**MONITORING YEAR 1
ANNUAL REPORT**
Final

CROSS CREEK RANCH SITE

Subject: Cross Creek Ranch Site – Monitoring Year 1 Draft Report
Montgomery County, NC
Yadkin River Basin – CU# 03040104
DMS Project ID No. 100138
Contract # 7879-01

Review Comments:

Cross Creek Ranch Site
DMS Project No. 100138
Monitoring Year 1 - 2022

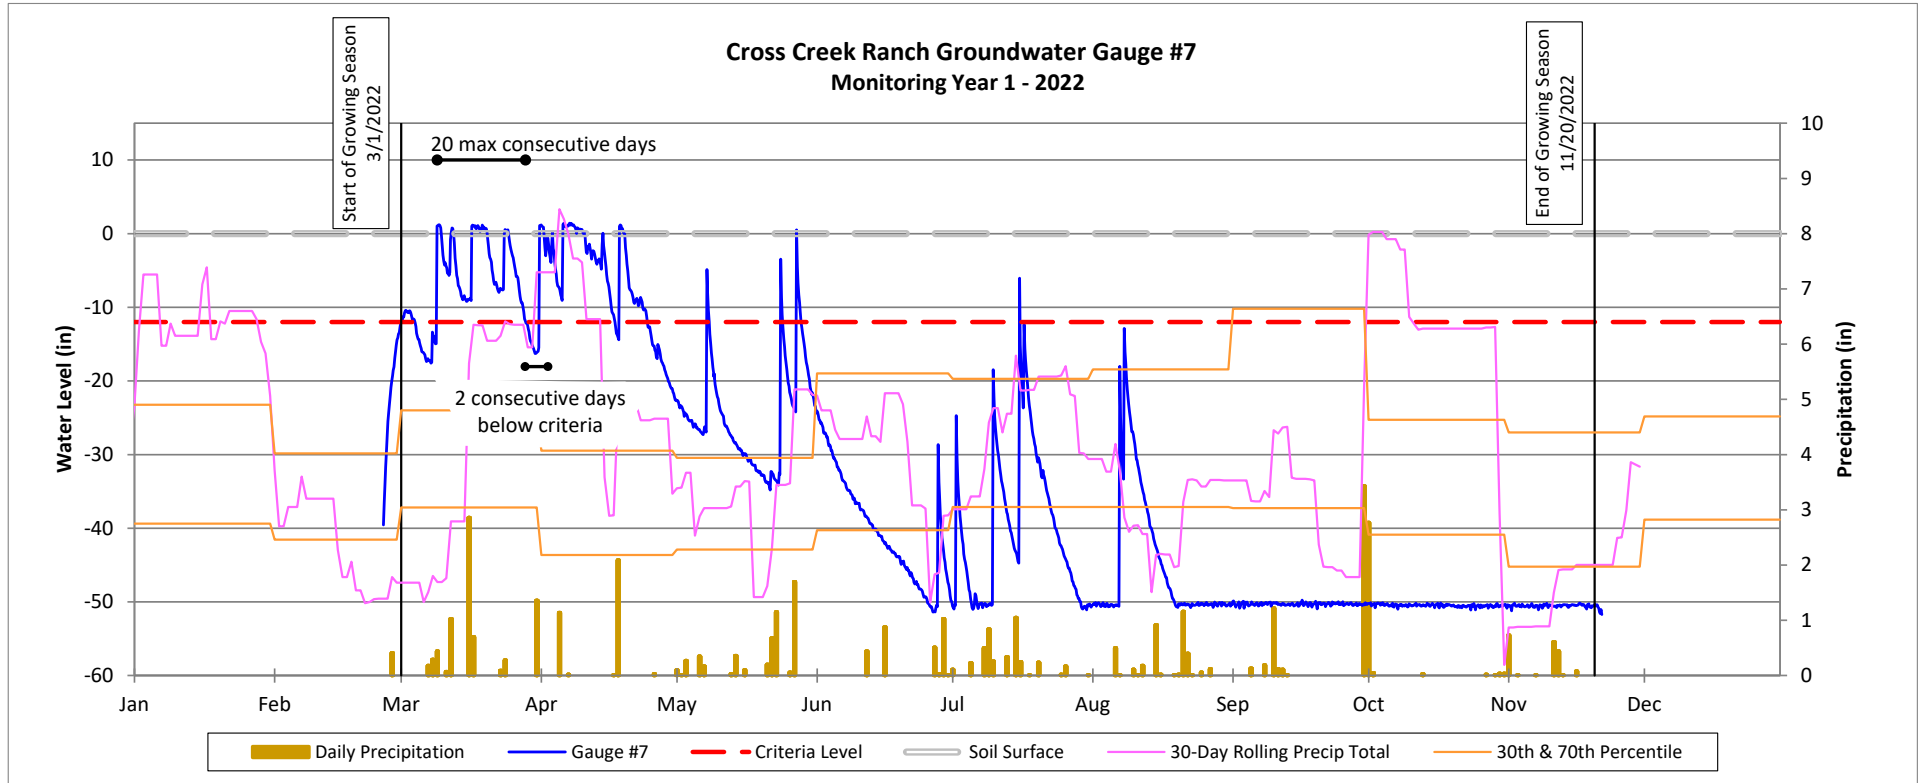
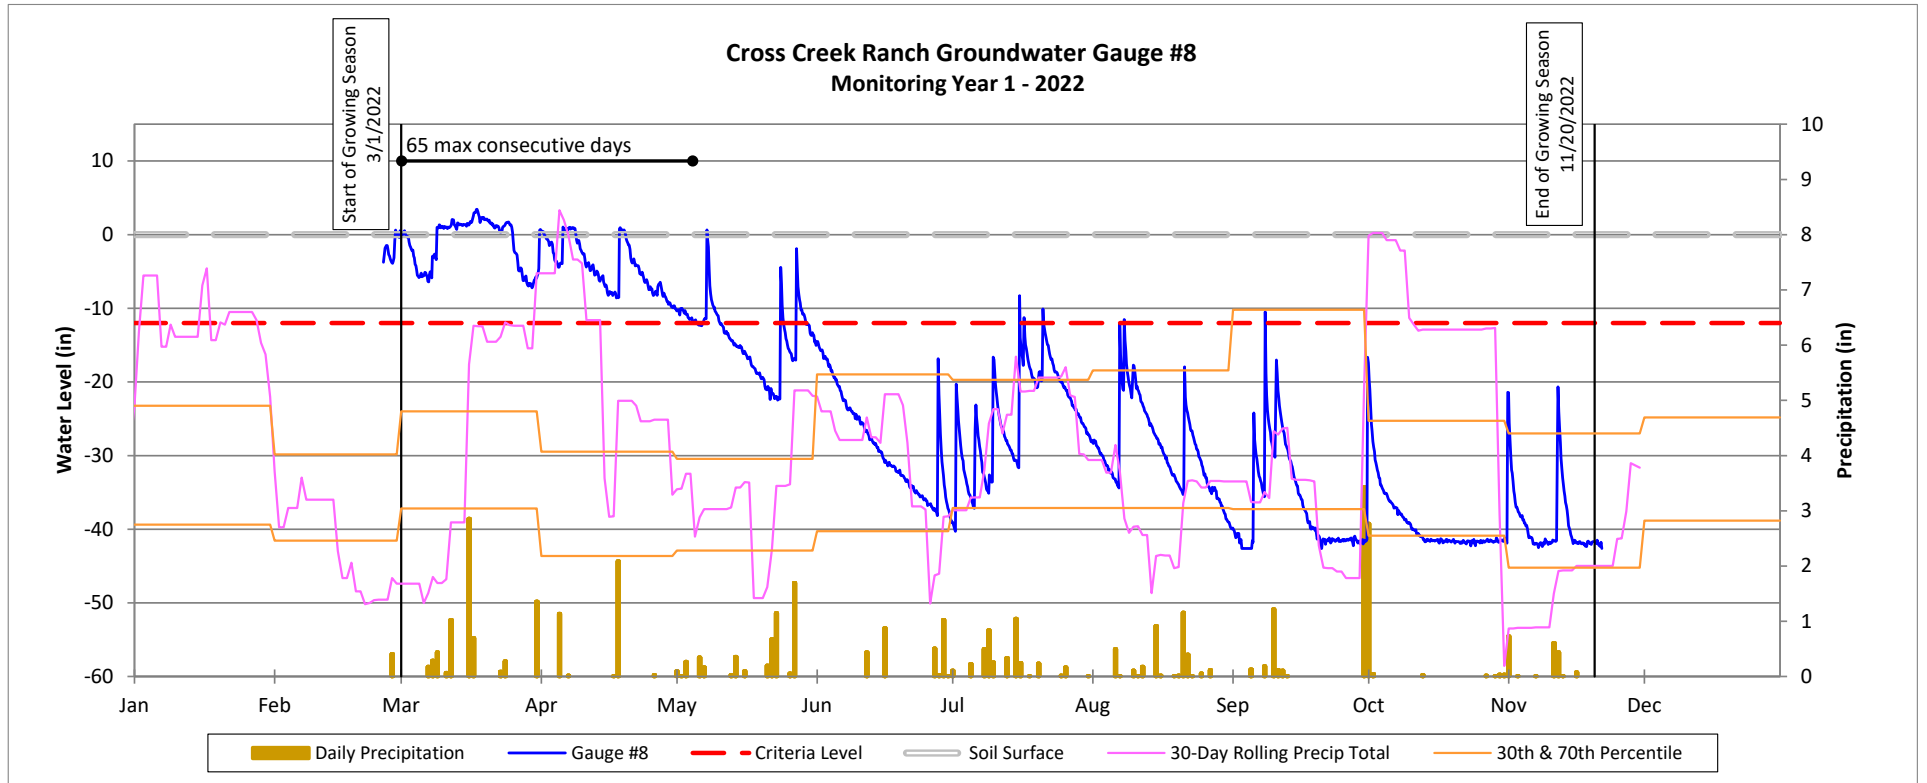
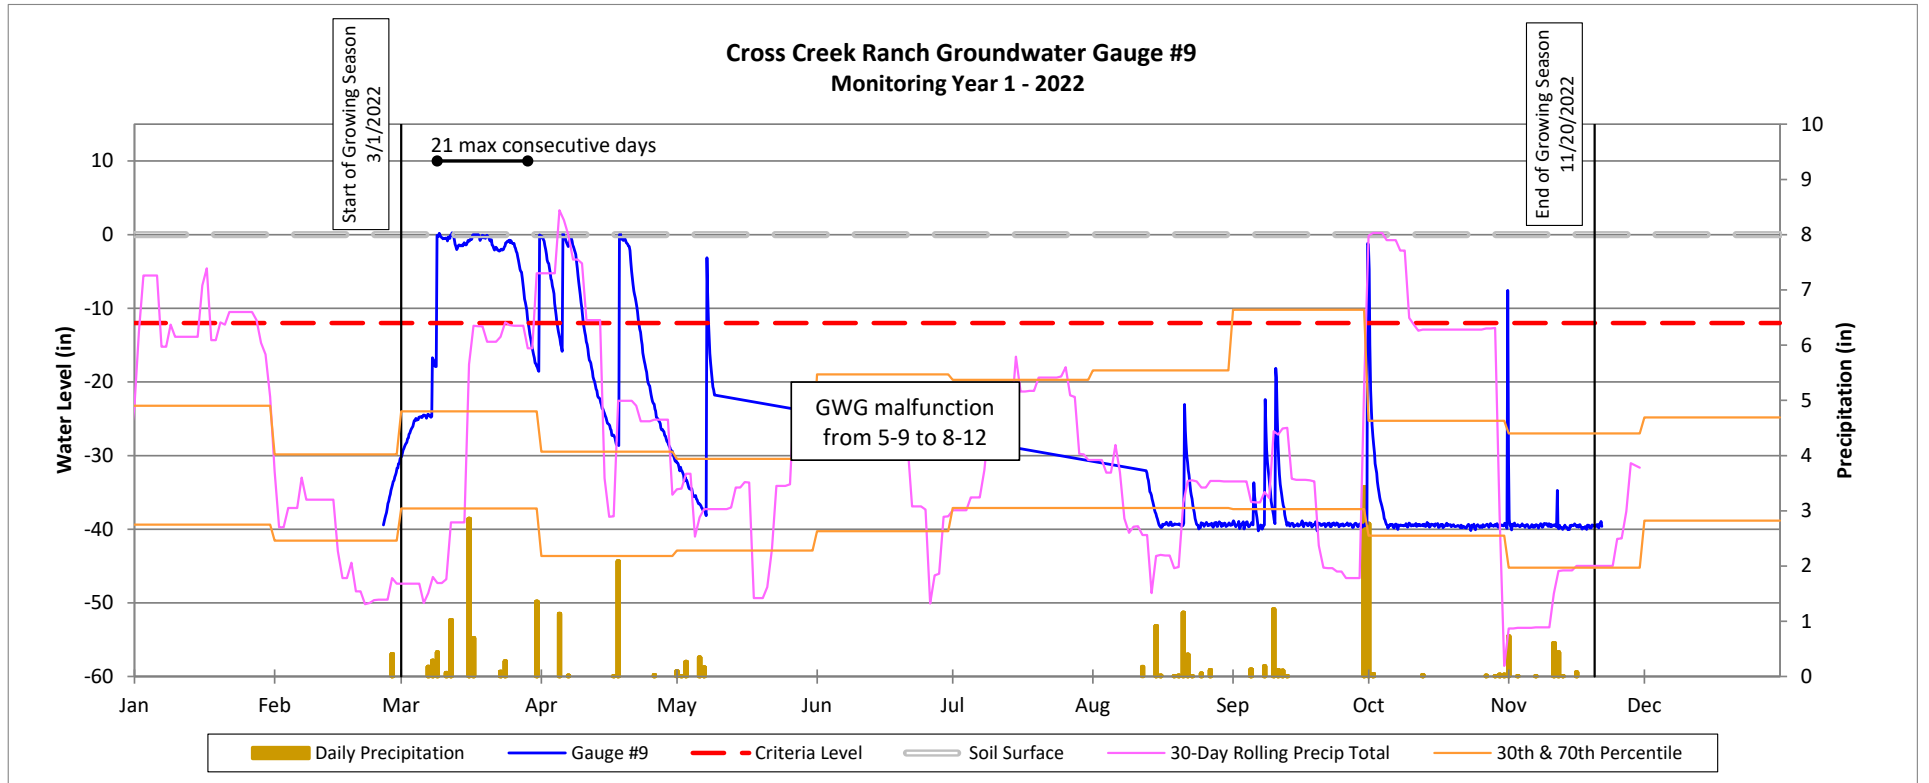
- [2.6 Wetland Assessment: Gages 2, 7, and 9 did not meet their respective hydroperiods. DMS conducted a field inspection on December 9, 2022, which raised the question, are these three wells representative and useful for interpreting wetland classification? Add discussion that identifies the relative gage locations and elevations within the local wetland topography. Are the gages installed on isolated ridges with localized wetland boundaries? Have the gages been field calibrated in their respective installations to accurately correlate their pressure readings with a measured depth to water from ground surface?](#)

Response: In an effort to best represent the conditions of each wetland re-establishment and rehabilitation zone, gauges 2, 7, and 9 are placed within the middle of their respective wetland boundaries. All gauges are calibrated correctly to accurately correlate their pressure readings with a measured depth to water from ground surface. After construction of the stream channel, it is anticipated that the groundwater table will take some time to recharge. Additional seasons of water table observation are required to better understand hydrology at the Site and thoroughly evaluate the success of wetland re-establishment areas. While Wildlands believes groundwater

wells 2, 7, and 9 to be placed in a way that best interprets wetland classifications, Wildlands will further investigate locations of gauges 2, 7, and 9 in MY2. Wildlands will continue to monitor the success of wetlands wells failing to make their hydroperiods and will add wells accordingly if needed in the future.
